UNITED STATES PATENT AND TRADEMARK OFFICE

10/567,478

Office Action Summary	Application No. 10/567,478	Applicant(s) NYSTROM, MARCUS	
	Examiner SEAN M. MICHALSKI	Art Unit 3724

DETAILED ACTION

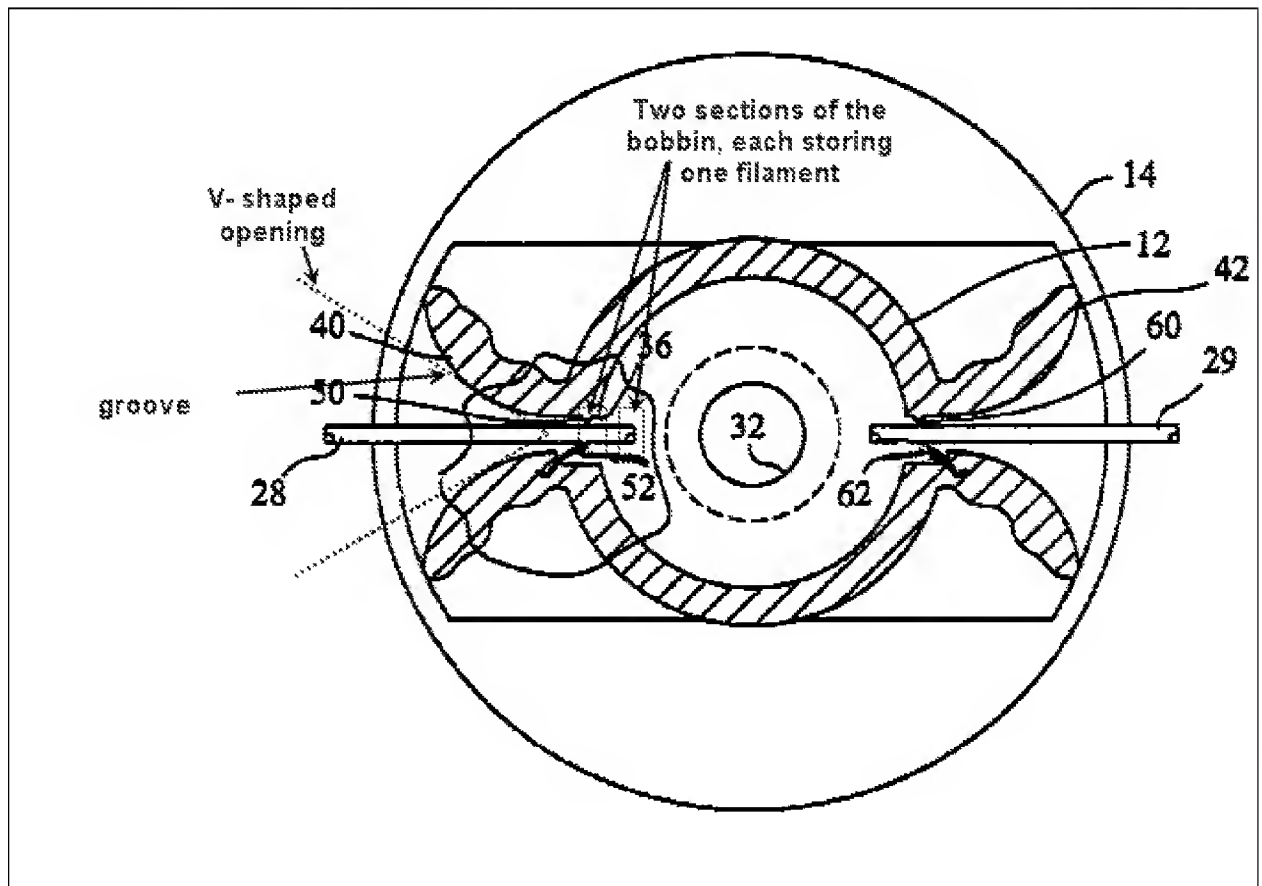
Fogle discloses a trimming head (14) including two eyelets (40/42 figure 4) and a bobbin (area interior of 62 is a bobbin, since that is the round area where the thread is stored), the eyelet provided with an opening (as seen in figure 4, through which filament 28 extends), the opening extending in an axial direction (the opening is three dimensional-therefore extends in all directions). Fogle discloses at least two sections in the bobbin capable of storing one cutting filament in each section, see below:

Are each of the “sections” shown above storing “a cutting filament”- Yes. Looking at them individually they may both be said to be storing a cutting filament, and they are both “sections” of the bobbin.

Fogle teaches a V-shaped opening, including a groove, as seen in the figure above.
